Technical Information Bulletin

CT660 Engine Injector Doser Nozzle Plugging {7000}

Media Number -TIBU7394-00 Publication Date -21/02/2014 Date Updated -21/02/2014

On Highway Truck:

Illustration 3

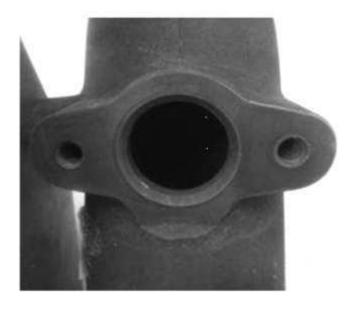
Below are photos of a partially plugged port Illustration 2, a completely plugged doser Illustration 3 and a clear port Illustration 4.
